Product Change Notice (PCN)

PCN Number: PCN-0460231R-01 **To Our Customers:**

Product(s) Affected: TB009-508 series

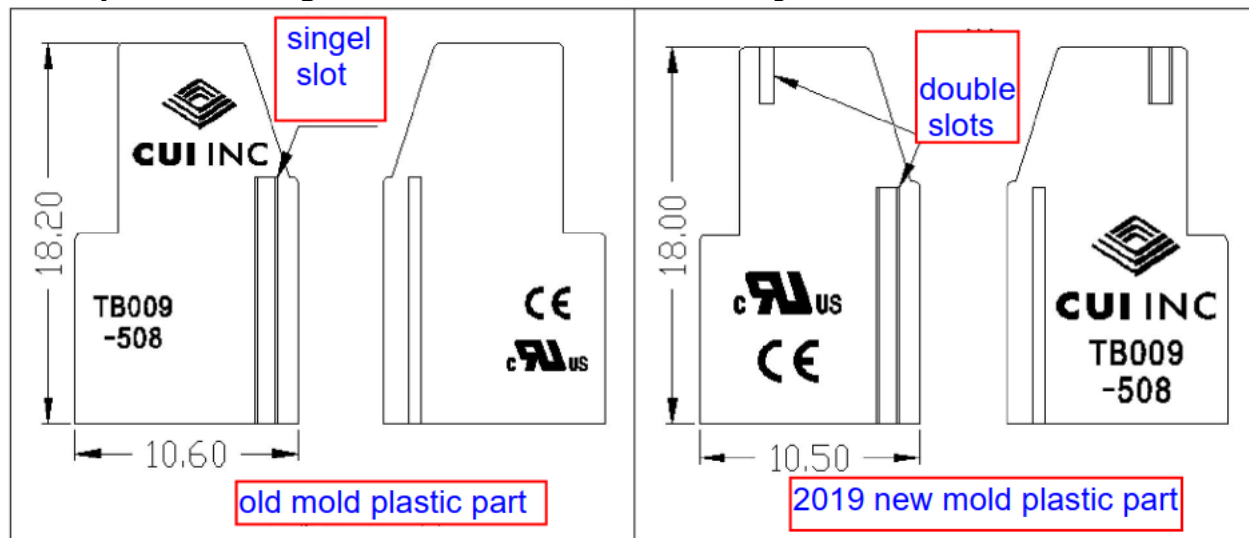
Reason(s) for Change: To promote the efficiency of automated assembly machine.

Description of Change: Additional slot for ease of configuration as shown below:

Additional Information: Products using the old mold cannot be connected to products using the new mold.
